SOLICITATION AMENDMENT
MODIFICATION DE L'INVITATION

Title - Sujet CABLE ASSEMBLY, SPECIAL PURPOSE	
Solicitation No. - N° de l'invitation W8482-133975/A	Amendment No. - N° modif. 005
Client Reference No. - N° de référence du client W8482-133975	Date 2013-01-10
GETS Reference No. - N° de référence de SEAG PW-\$\$HN-379-61537	
File No. - N° de dossier hn379.W8482-133975	CCC No./N° CCC - FMS No./N° VME
Solicitation Closes - L'invitation prend fin at - à 02:00 PM on - le 2013-01-25	Time Zone Fuseau horaire Eastern Daylight Saving Time EDT
F.O.B. - F.A.B. Plant-Usine: <input type="checkbox"/> Destination: <input checked="" type="checkbox"/> Other-Autre: <input type="checkbox"/>	
Address Enquiries to: - Adresser toutes questions à: Godbout, Lyne	Buyer Id - Id de l'acheteur hn379
Telephone No. - N° de téléphone (819) 956-3611 ()	FAX No. - N° de FAX (-) -
Destination - of Goods, Services, and Construction: Destination - des biens, services et construction:

Amendment 005 is raised to give additional information on the specifics of this cable assembly.

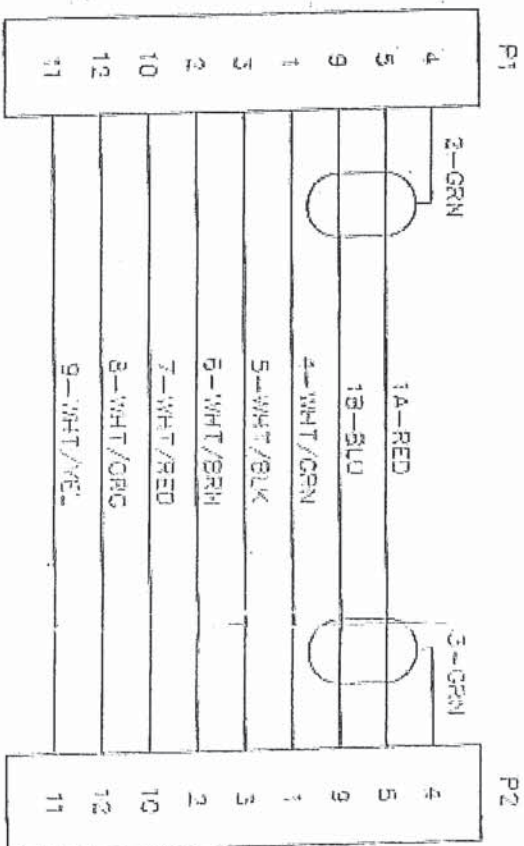
Here is the parts list going with Annex A.

P 1 1EA item 0001 M28840/16AC1P1

P 2 1EA item 0002 M28840/11AC1S1

2EA item 0003 9260771-3 Backshell Kit

19.65 Ft item 0004 9260772-1 cable Shielded

1.00 Ft item 0005 M16878/4BEE5 Wire Elec Insul, 24 AWG GRN

2EA item 0006 M83519/1-2 Splice, shield Termination

24EA item 0007 MS27488-20 Plug Sealing

1EA item 0008 8763751-2 Marker. Sleeve (Wraparound 1 1/4" width)
